Enclosed are the meeting minutes for the 116-B-6-1 ISV Demonstration Project and final comments on the 116-B-6-1 Site Characterization Plan from Ward Staubit (USGS).

MEETING MINUTES

Subject: Site characterization plan for ISV demonstration project

FIGURE 13. Map of the 116-B-6A Showing Proposed Borehole and Well Locations

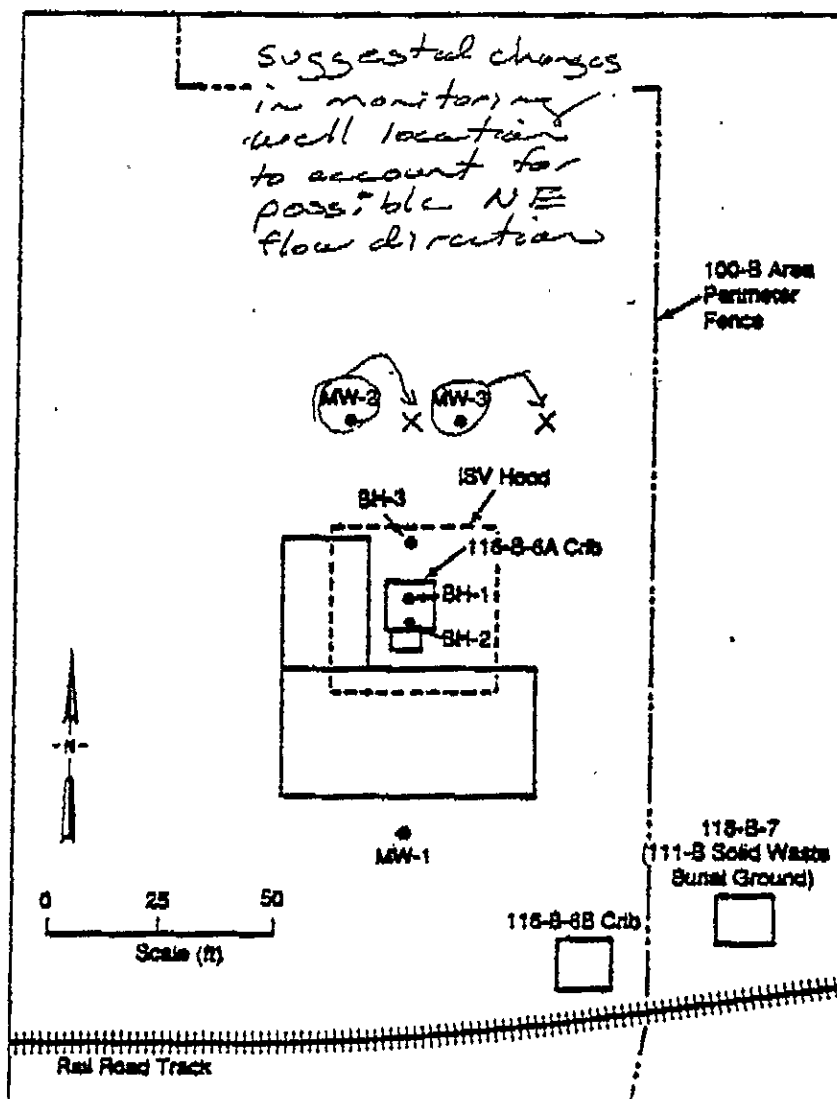
As we discussed on the phone this morning, I am transmitting my comments on the proposed locations of monitoring wells for the ISV demonstration project. The ground-water gradient along streams that serve as ground-water discharge areas is often skewed in the down stream direction. An examination of Figure 11 indicates that ground water may indeed flow in a northeasterly direction in the vicinity of the 100-BC area. Ground-water levels measured in the 300 area indicate that this effect can occur greater than 3000 feet from the Columbia River. We therefore recommend adjusting the well locations noted in Figure 13 to better account for possible northeasterly flow. I have included a copy of Figure 13 with these recommended changes for your information. If you would like to discuss this further, I can be reached at FTS 390 6510.

Mr. W. Staubitz called Mr. J. Sands on 7-19-89 to give his comments on the ground water well drilling. His comments are attached. PNL will incorporate these comments, via page changes, into the Characterization Plan. PNL will also start ground water well drilling in accordance with the comments given.
